IEC/IEEE 60802 D2.1 YANG comments #571, #570, and #130

Josef Dorr, Siemens AG

IEC/IEEE 60802 YANG Modules - Overview

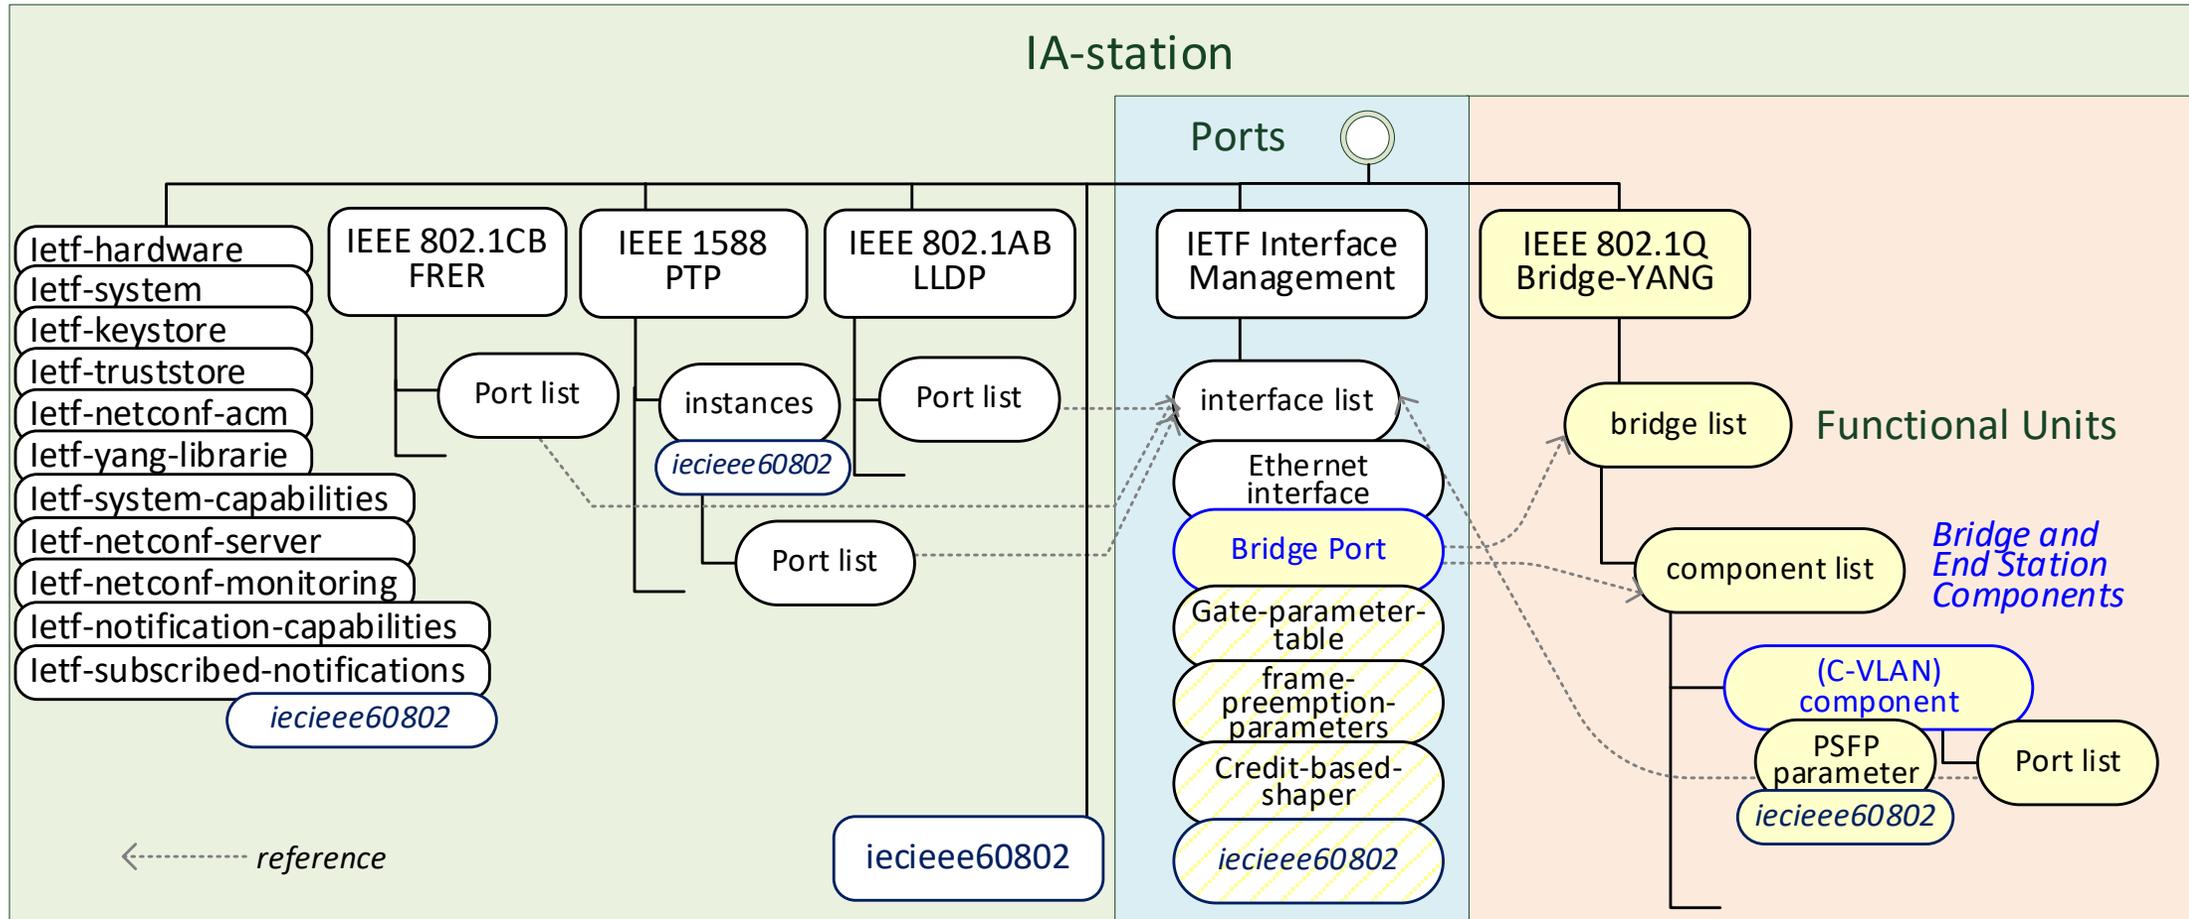
“Mandatory values in End Stations: it is unclear why the bridge YANG module is needed and which “Bridge-Type” it should be. Most values have absolutely no meaning such as msti. The overhead for maintaining a filter database does at least at send direction not provide any advantage. There is no clear definition what to do with bridge items in an end station and most end station designs as of today may not have an extended filtering database.

Suggested Remedy: Move Bridge Yang module to bridge requirements.”

1. YES, because ...
the Bridge-YANG module provides the nodes to configure: VLANs, Traffic Classes, Transmission Selection, ... for bridge and end station components in a uniform way.
2. Is the node selection for bridge and end station components identical?
No – the node selection for end station components can be restricted.
3. What Bridge-YANG nodes shall an end station component support?
See next slides.

Flow Meter Configuration Model according to IEEE 802.1Q-2022

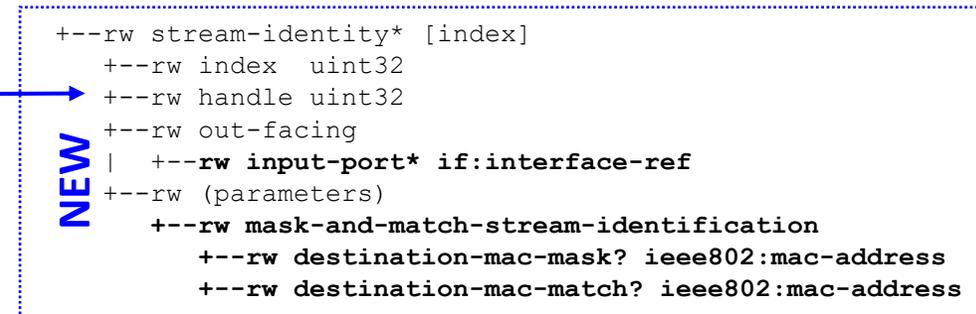
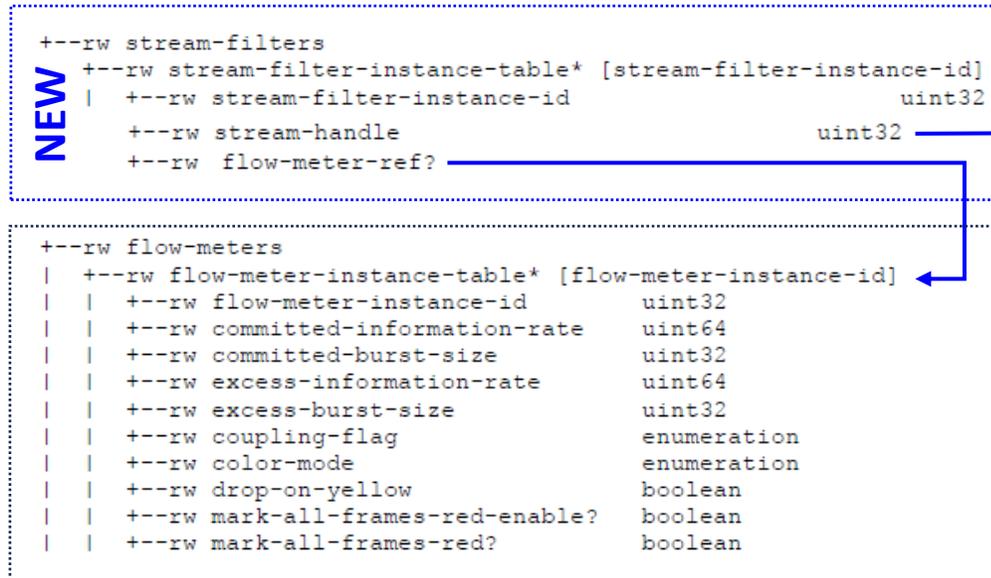
“According to 5.7.1 l) it should be possible to assign flow meters to ports; however, the selected nodes [of the ieee802-dot1q-psfp-bridge YANG module] do not allow this assignment.

Suggested Remedy: clarify how flow meters can be assigned to ports.”

- Flow meters are traffic filters.
- Traffic specification and port assignment are configured using Stream Filters.
